**Navy Response to Agency Comments on the
Draft Parcel B Technical Memorandum in
Support of a Record of Decision
Amendment**

**Hunters Point Shipyard
San Francisco, California**

December 8, 2006

**FIGURE 1-4
PLANNED VERSUS ACTUAL
EXCAVATIONS**

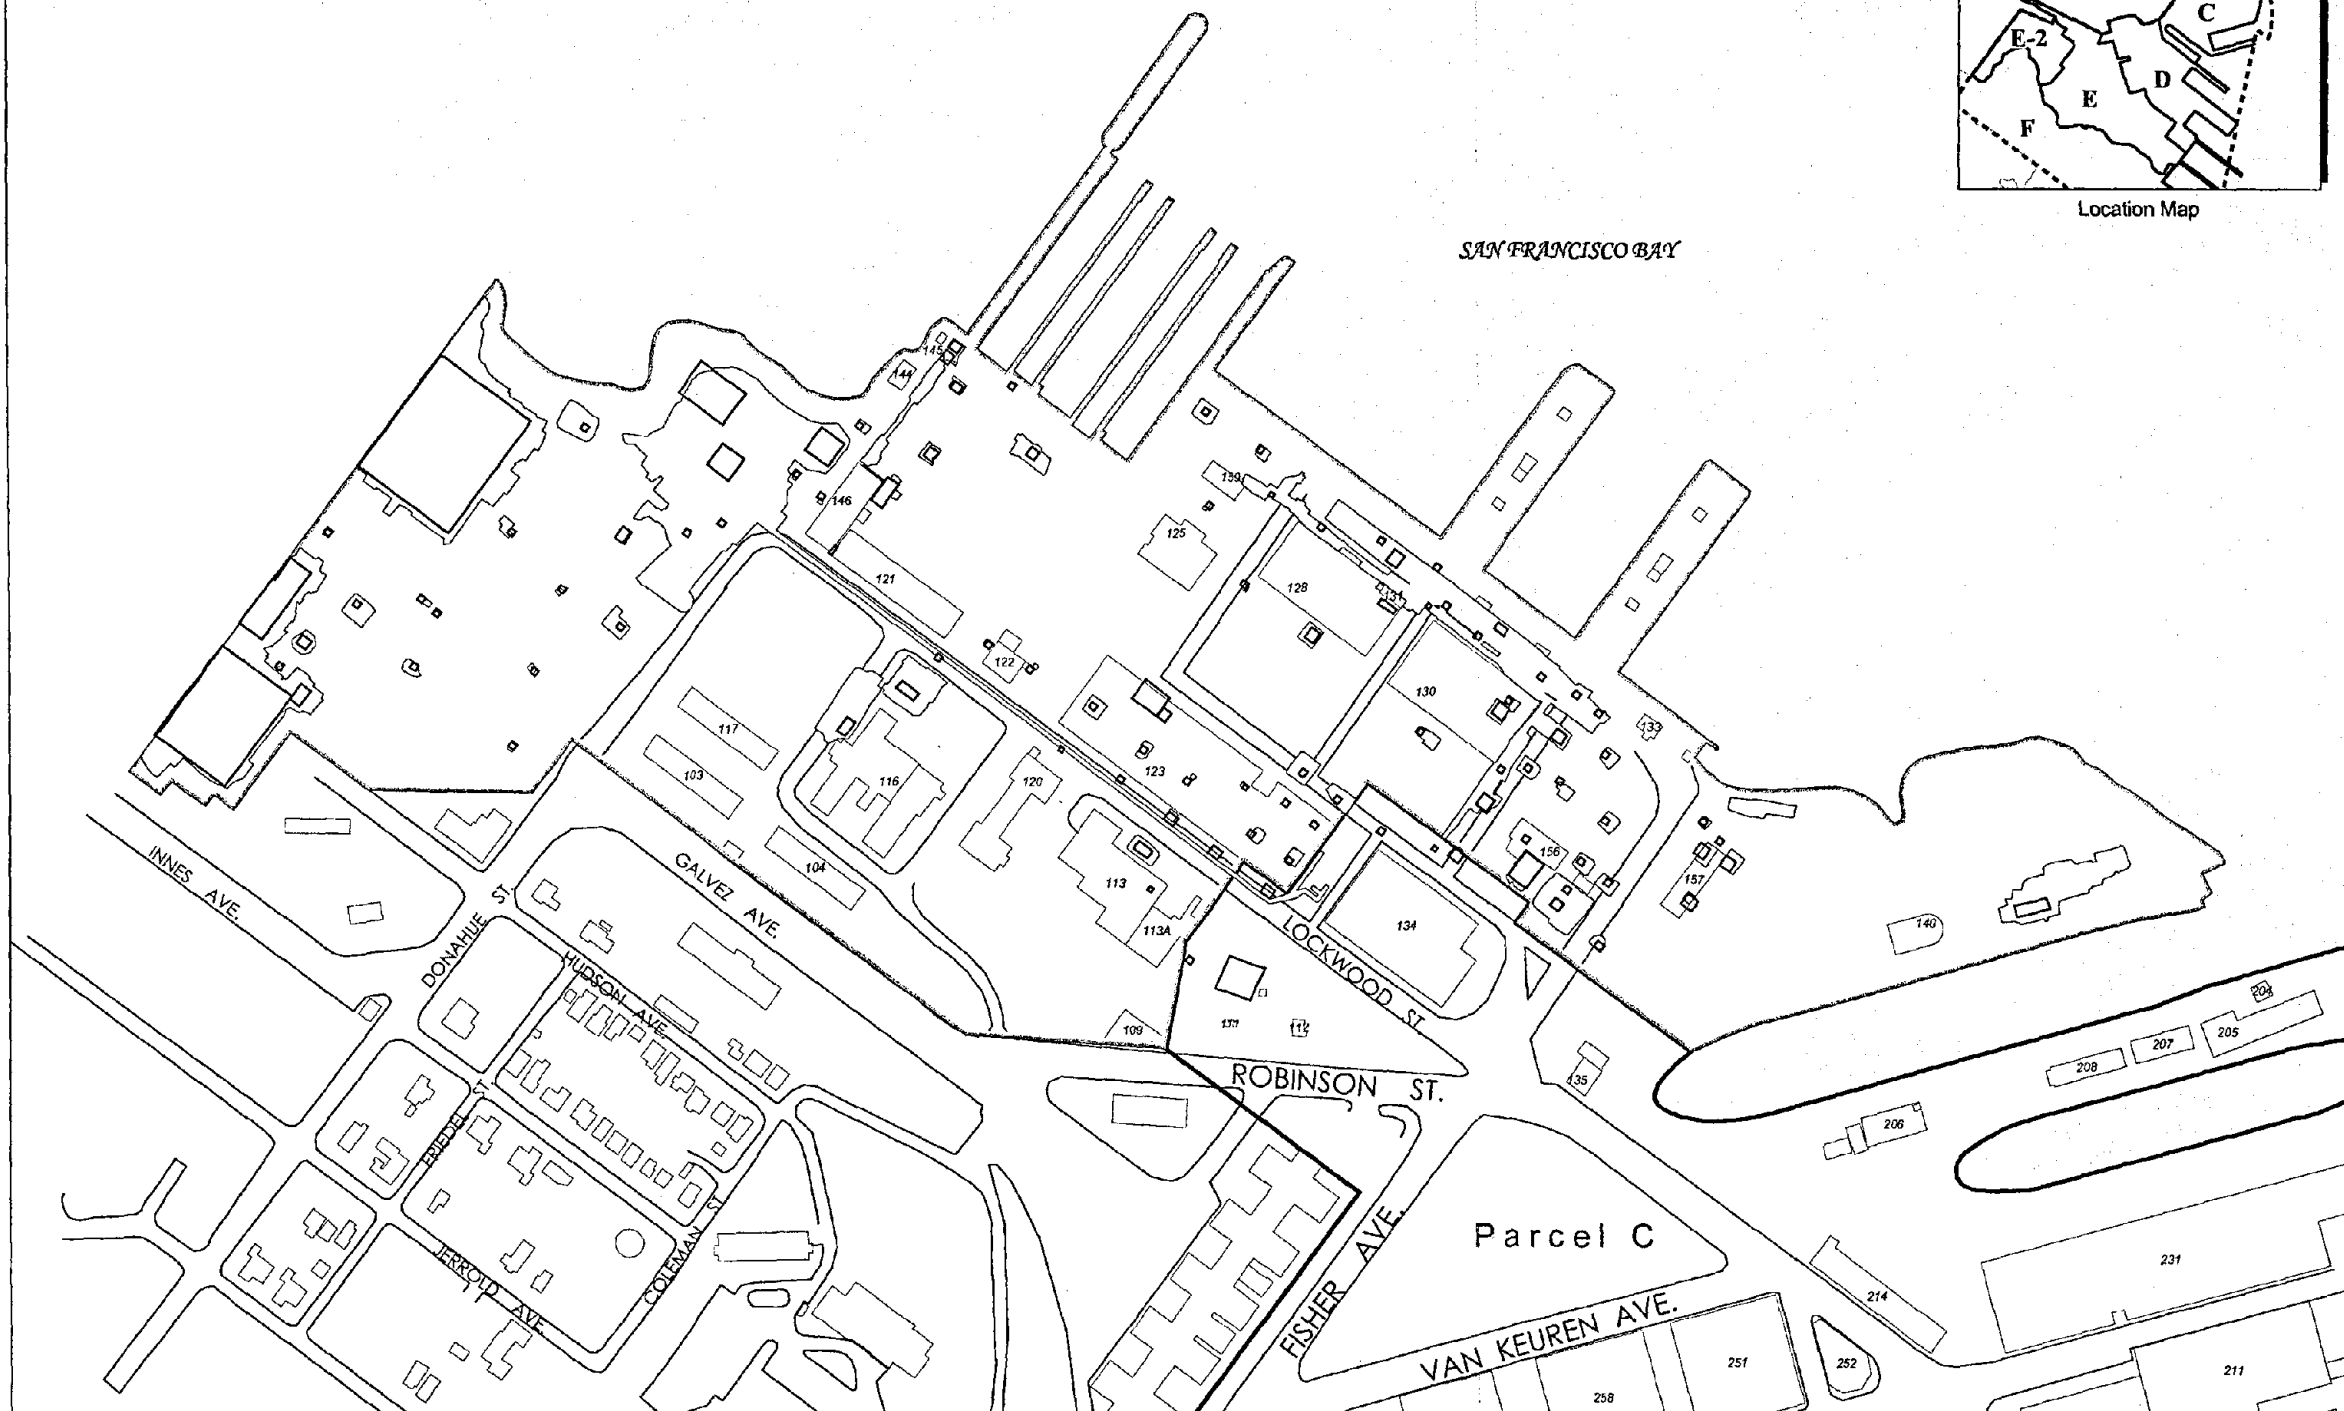
Comparison of the remedial action envisioned in the ROD to the actions completed to date illustrates the large difference between the planned and actual site conditions at Parcel B. The estimate in the ROD for the remedial action included removal of 38,000 cubic yards of soil over a period of 3 to 6 months at a cost of \$11.2 million. The remedial action at Parcel B removed over 100,000 cubic yards of soil over an active excavation period of 31 months at a cost of more than \$40 million. Figure 1-4 presents a comparison of the excavation areas estimated in the ROD to the actual remedial action excavations.
